Design Review Subcommittee (DRSC)

Meeting Date: January 24, 2024

SUBJECT: **Housing Element Implementation Program – Objective Design Standards**, second review of the draft objective design standards for multi-family and mixed-use development to meet the City’s Housing Element requirements.

A.3.c. street lighting to be provided per city standard.

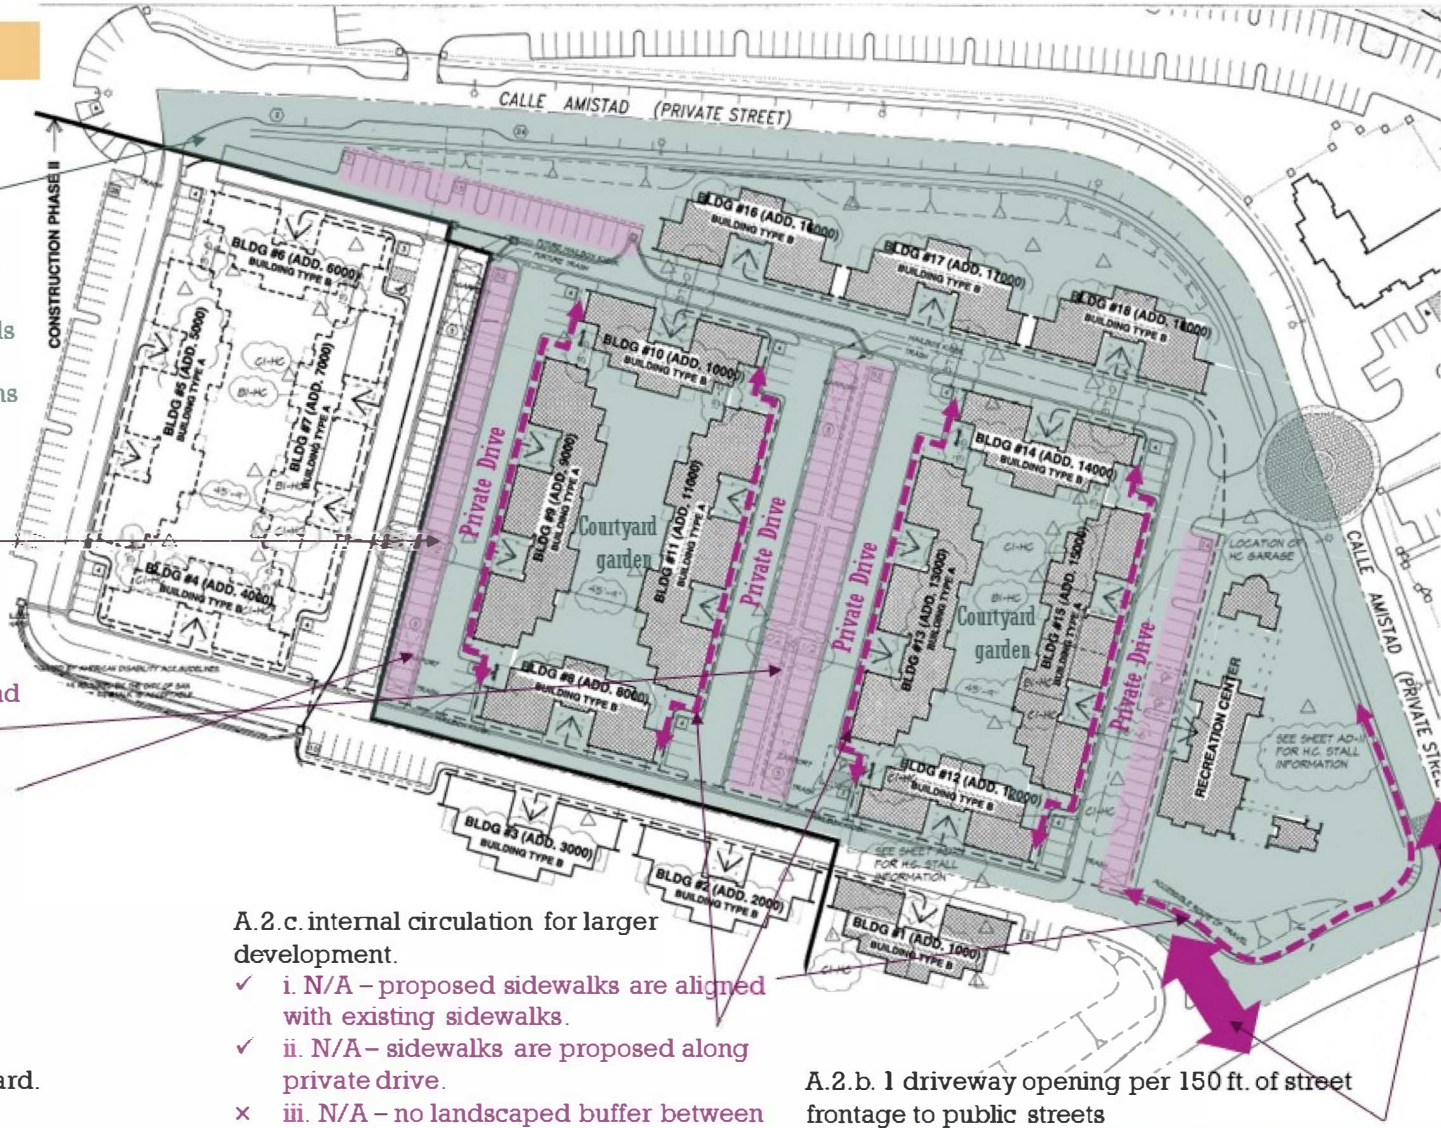
- ✗ Lighting not specified
